# **Product Change Notification**

## **113776 - 00**

**Change Notification #:** 113776 - 00  
**Change Title:** Intel® Server System P4308IP4LHJC  
PCN 113776-00  
Label  
Update the Safety label with an EAC logo  
instead of a GOST logo  
**Date of Publication:** April 10, 2015

Figure-1: Pre-Change

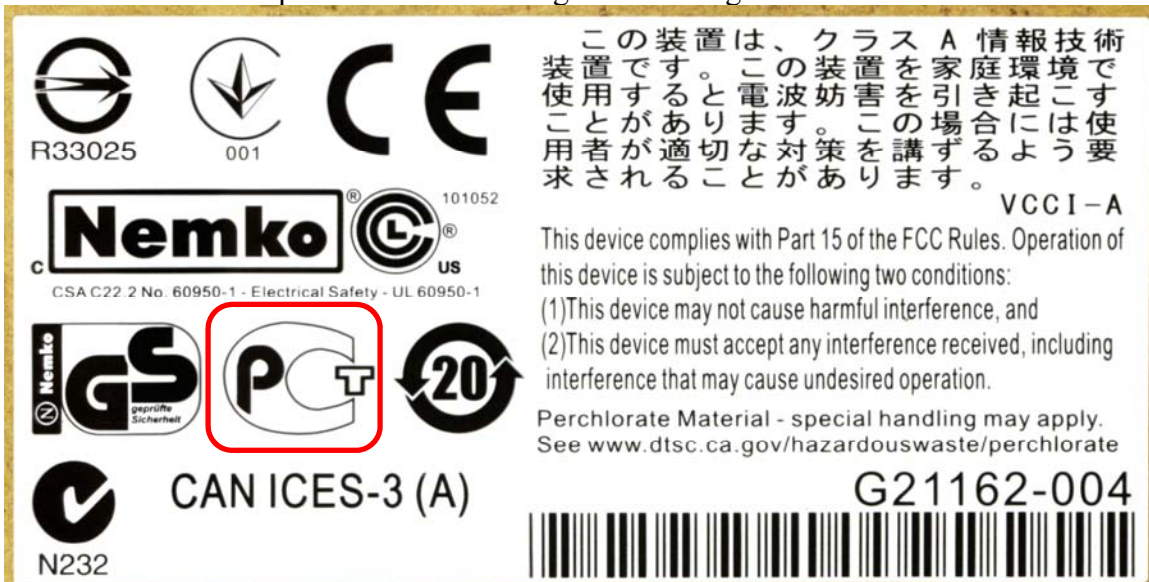
- Update the Safety Label: Put an EAC logo instead of a GOST logo for certification update. Please see Figure-1 and Figure-2 below for details.
